**COUNTY OF SAN LUIS OBISPO BOARD OF SUPERVISORS
AGENDA ITEM TRANSMITTAL**

RE: Permit for a 3-D high-energy offshore seismic reflection survey,
Central Coastal California Seismic Imaging Project (CCCSIP) near Diablo Canyon
Power Plant, to be heard August 14, 2012

RE: Central Coastal California Seismic Imaging Project (CCCSIP) – High-energy 3D seismic reflection survey near Diablo Canyon Power Plant (DCPP)

Response to June 20, 2012, Request for Information

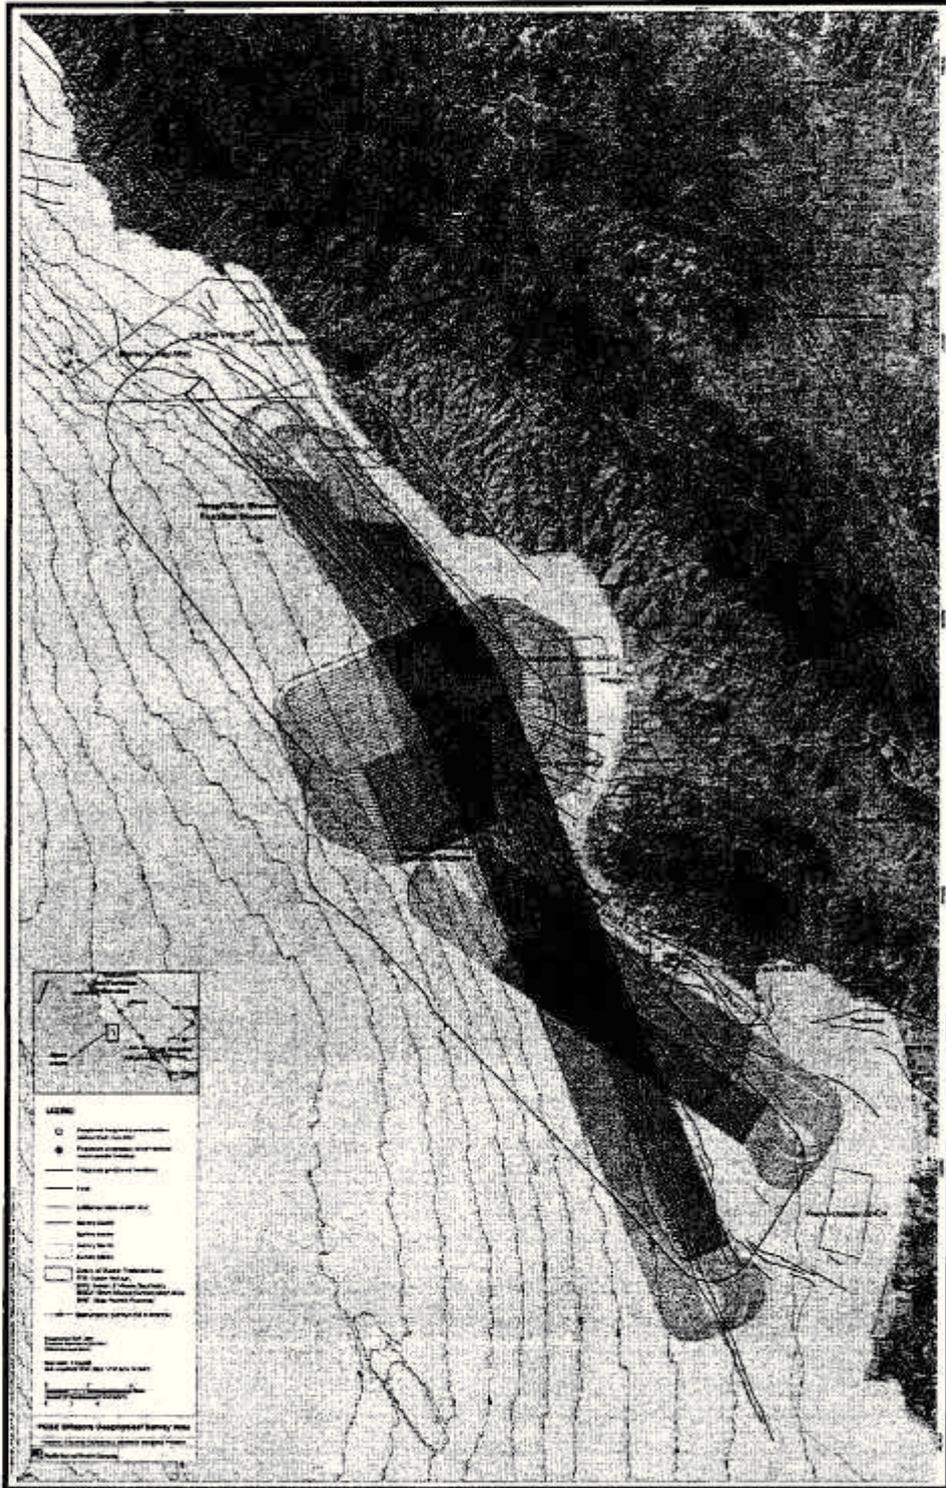
The IPRP has suggested eliminating the northernmost part of the survey (Box 3) because little new seismic hazard information was expected to be obtained (IPRP Report #3). In their response to the IPRP, PG&E disagrees, arguing that further survey of the Hosgri-San Simeon fault intersection could reveal important geologic detail.

Note that the survey direction of Box 3 (Attachment 2, Figure 1) is along the strike of the Hosgri-San Simeon faults. PG&E argues that this shooting orientation is necessary because shallow water near the shoreline constrains boat maneuvering. Strike line shooting is less preferred because the important geologic changes occur in the perpendicular (dip) direction (Attachment 2, pg 4).

The cross-line bin size of the HESS is nominally 25-37m. PG&E discusses in Attachment 2 that the onshore data show optimal group interval is closer to 10 m. Thus, the adequacy of the cross-line (dip direction) sampling in Box 3 (and other areas shooting along strike) should be reviewed.

As with other issues above, a comprehensive survey design approach would model the expected reflection response for the proposed survey geometry and processing sequence to confirm that features could be adequately imaged. This should be especially important in the northernmost area of the survey, where geologic details are to be assessed. A second shooting boat and streamer track overlap could also benefit cross-line resolution and should be studied.

As shown in Figure 1, HESS Survey Box 4 in Estero Bay is oriented to be roughly perpendicular to the strikes of the Shoreline, Los Osos and Hosgri faults and provides an opportunity to conduct dip survey lines in this area. This would provide a broader azimuthal coverage of complex geologic structures in the area, consistent with PG&E's response to Request 5.

better acquisition strategy would consist of overlapping 3-D survey boxes (e.g., Boxes 2 and 4 in Figure 1), shot from different azimuths, using a narrow footprint of towed streamers to ensure both safety, the ability to image the shallow most sections of the crust, and estimate crustal anisotropy.

Figure 4 Typical Transition Zone Processing Flow.

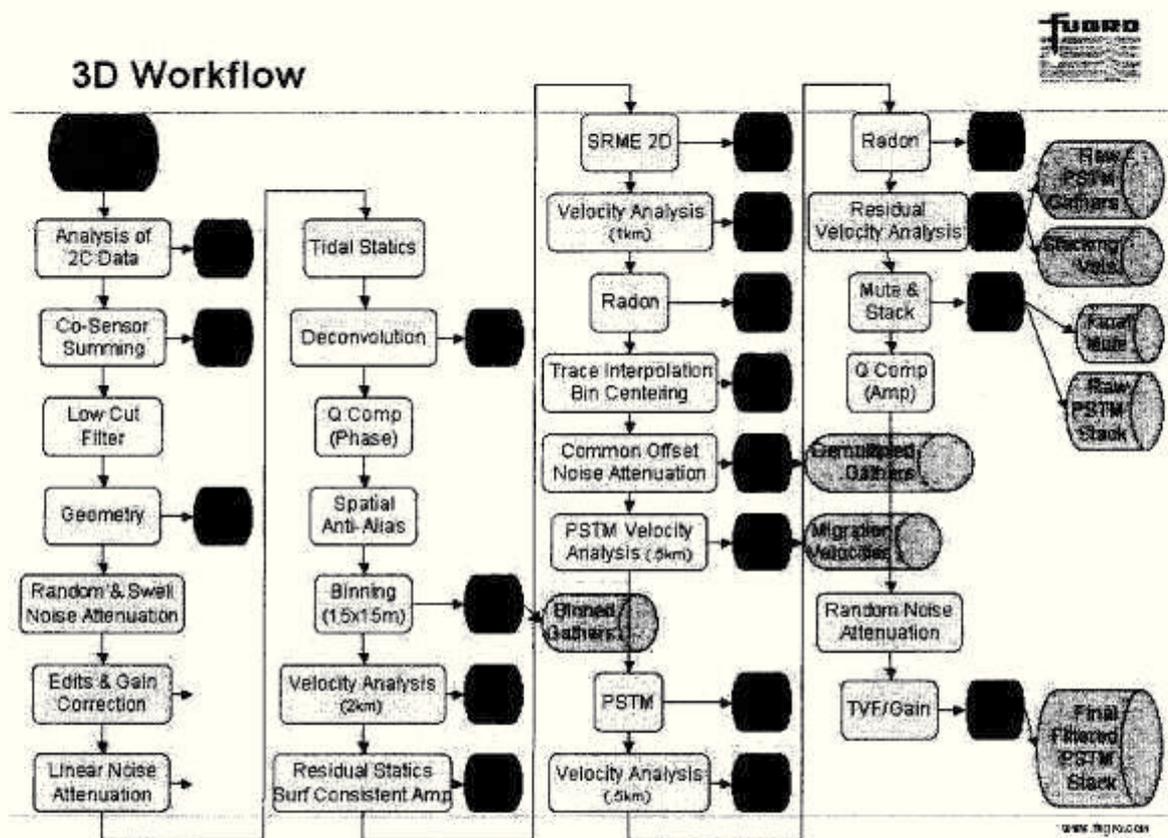
In this case shallow water receivers (nodes) are proposed along 5 irregularly spaced and oriented lines. While plots of common-midpoint coverage have been offered, there remain questions about whether this survey geometry can image the structures of interest.

Industry standard transition zone survey design would have modeled the seismic response of expected targets and adjusted survey geometry and data processing flow to assure image quality. The data processing flow is particularly important if data from the

A processing flow of these Transition nodal data is shown in Figure 4. Once these data are processed they will be integrated with the onshore and offshore data to develop a comprehensive 3D volume of the study area for interpretation.
